Release Notes

Document No.: RN-240702-01
Date: 2nd July, 2024
Classification: External
Attn: Inmarsat customers
Related Products: GXNX series
Subject: iARM & antenna FW Release Notes

Image 1. GPS set up

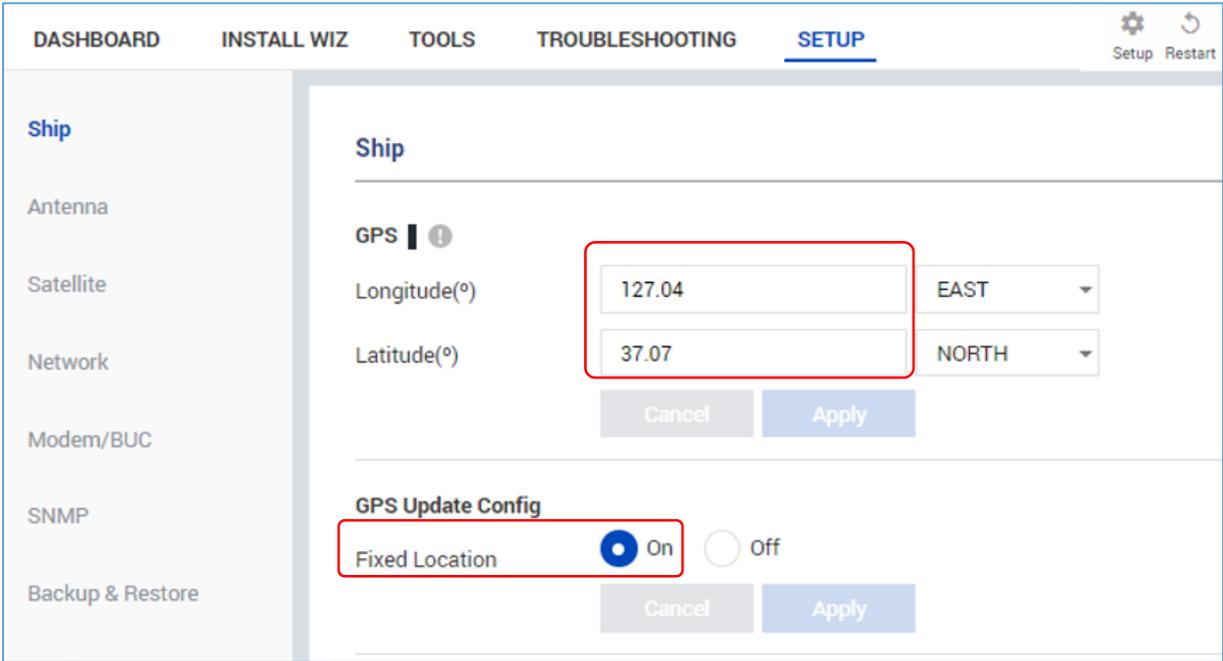
Go to setup menu, turn on the fixed location function on the 'GPS update config' and click apply. Go to the 'Ship' category and input the location and click 'Apply' button.

Image 2. Ship information in dashboard

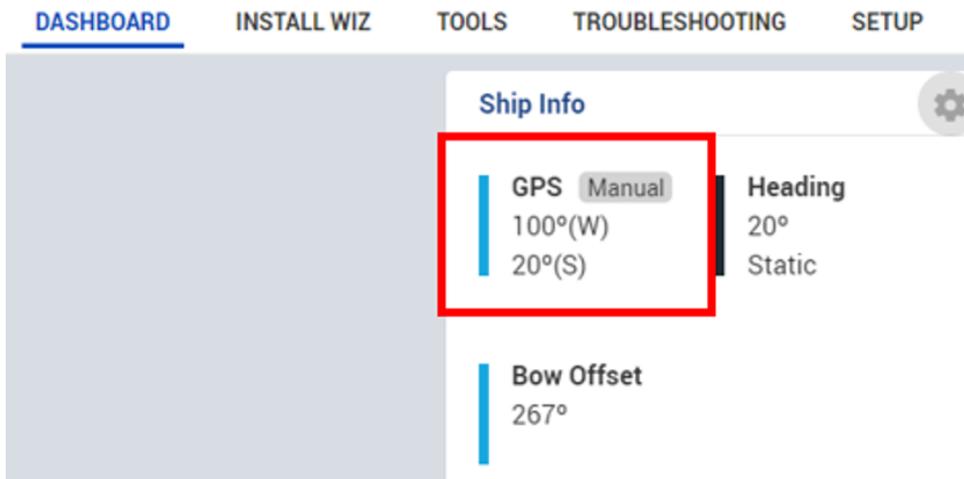
NOTE: If you turn on the Fixed Location function, 'Manual' icon appeared on the Ship info of the Dashboard.

Image 4. BDT(ACU) rear GYRO port

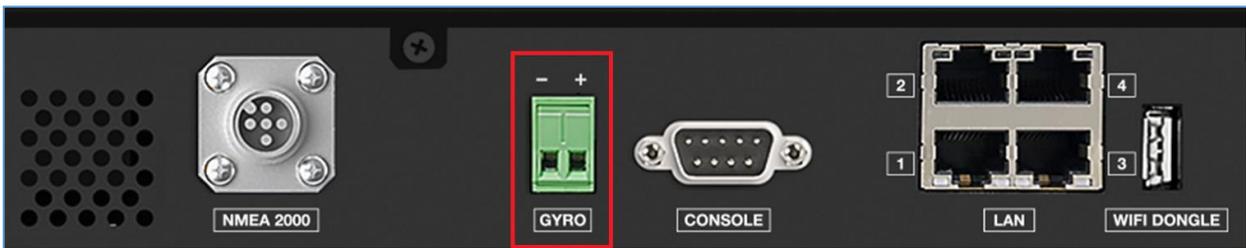
Input NMEA signal using UART signal to the corresponding port. If the signal is valid, the external GPS signal is prioritized. If the signal from the GYRO port is lost, the Antenna system will automatically switch to the internal GPS signal after 60 seconds.

Image 5. Ship information in dashboard for external GPS

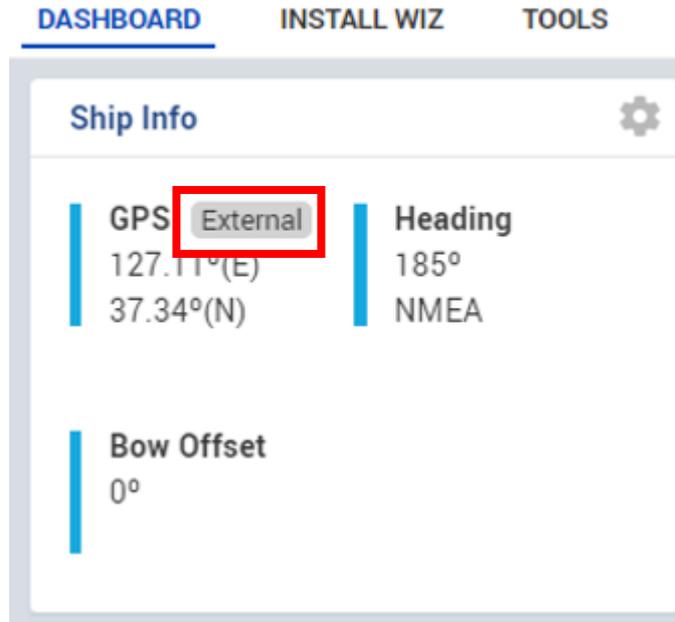
Manual GPS setting is also available while using external GPS, and it will automatically switch to internal GPS when the setting is disabled.

Image 6. Secondary setup

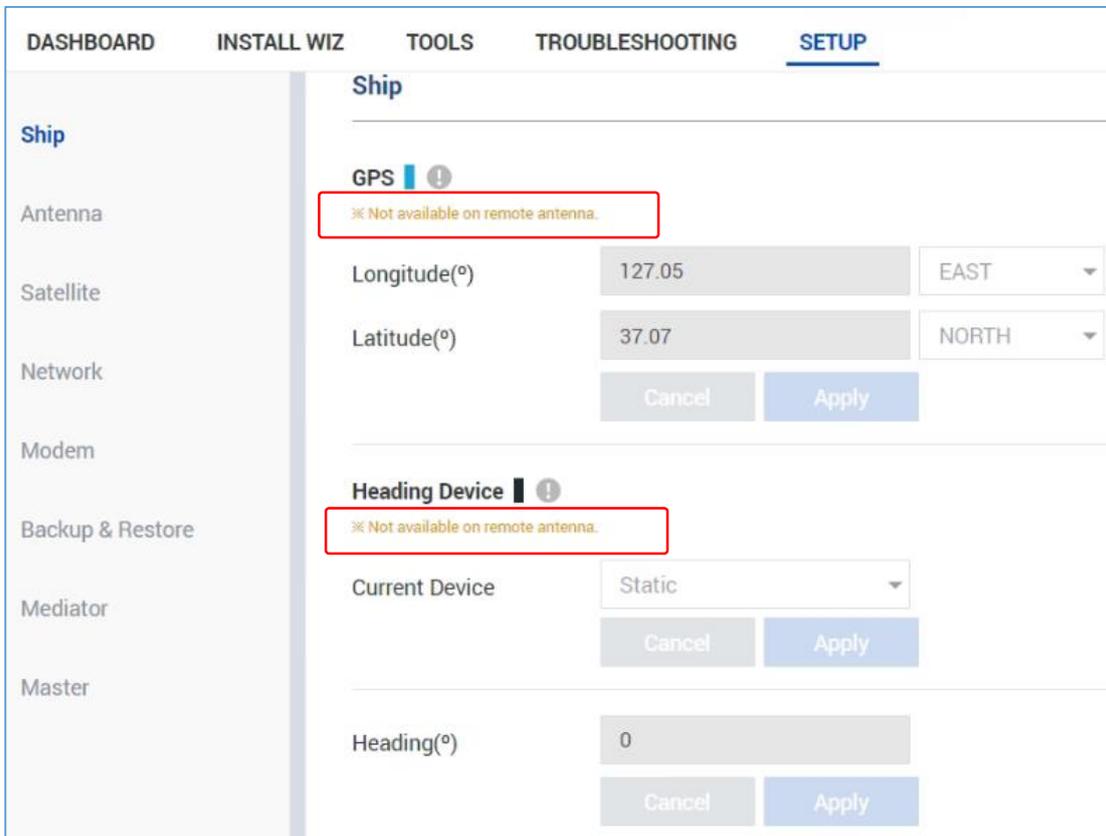
Secondary GPS and heading settings are dependent on the primary.

GPS data & heading data cannot be modified, it is dependent on primary's setting
